Planning Application Ref: 1629/22/ARM Address: Dennings Wallingford Road Kingsbridge TQ7 1NF Description: Application for approval of reserved matters following outline approval 2574/16/OPA (Outline application with all matters reserved for 14 new dwellings) relating to access, appearance, landscaping, layout and scale and discharge of outline planning conditions

Planning Application Ref: 1386/22/FUL Address: Dennings Wallingford Road Kingsbridge TQ7 1NF Description: Erection of six new residential dwellings (resubmission of 3830/20/FUL)

## LETTER OF OBJECTION FROM THE SOUTH HAMS SOCIETY

Sediment runoff from the new Dennings' fields entrance on the 4<sup>th</sup> of June in Cow Lane:

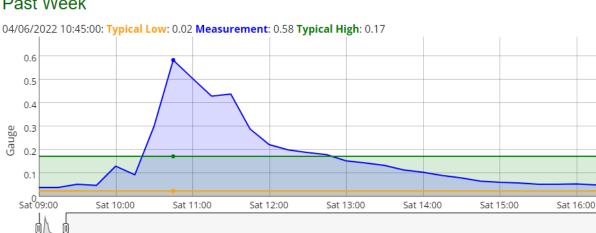
• It was reported that muddy water overwhelmed the drains and was seen coming out of a development site to the east of Stentiford Hill.

Water runs off the end of Applegate Way:

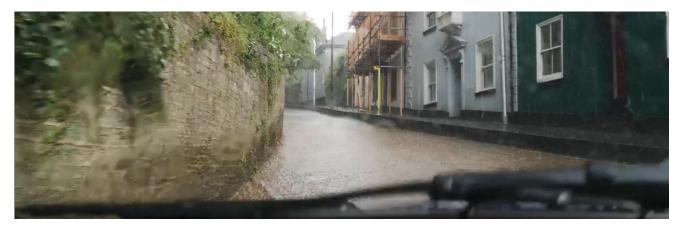
In addition to the changes to the Dennings' fields, to the east of the Dennings site, the new Applegate Park site has continued to allow surface water to enter Dennings' fields below. This could be seen on the morning of 21<sup>st</sup> November 2022 with a stream running off the end of Applegate Way running straight through the hedgerow to the Dennings' fields below.

This combines with the run off from the 2.26 Hectare field/s of Dennings'.

This new drain is not working and will not work. Any new development at the bottom of this field is at high risk of surface water flooding during any flash flood event from the Applegate development.
